Re: Recall Nos.00V-365 and 00V-384, Supplemental Information

NINJA® ZX-12R FUEL TANK OVERFLOW PIPE AND FUEL GAUGE WARNING AND RECALL NOTICE

RECALL SERVICE BULLETIN MC 00-13 DATED 12/22/00

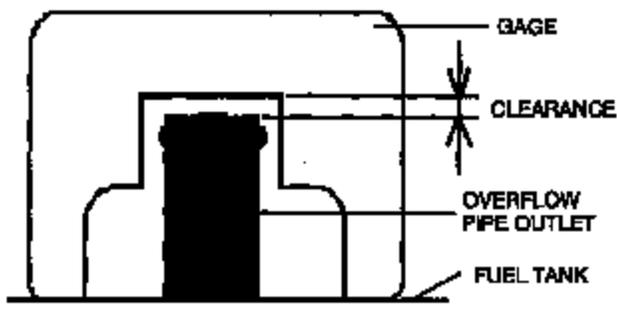
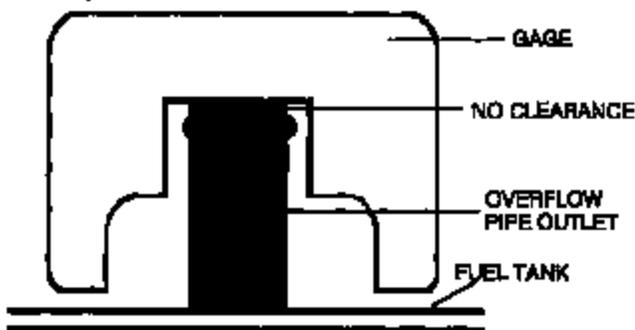
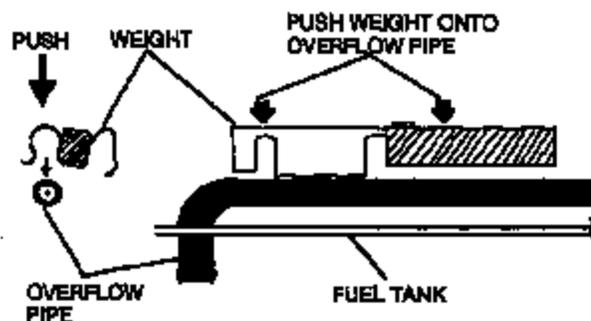
- Check the clearance between the gage and the tip of the pipe.
- ★ If there is some clearance, use the weight marked with "L" from the kit.

- ★ If there is zero clearance, use the non-marked weight.

Install the weight on the overflow pipe as shown. Perform this installation work through the hole for the fuel pump.

- A. Punch Mark
- B. Front Fork (right)
- C. Vehicle Identification Number
- D. Frame

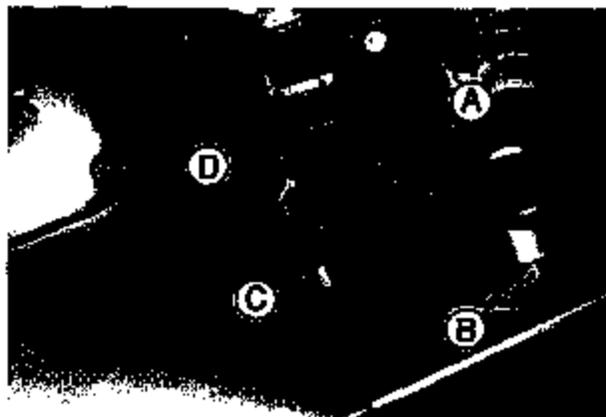
- After completing required repairs, make a punch mark at the end of the Vehicle Identification Number on the right side of the steering head.
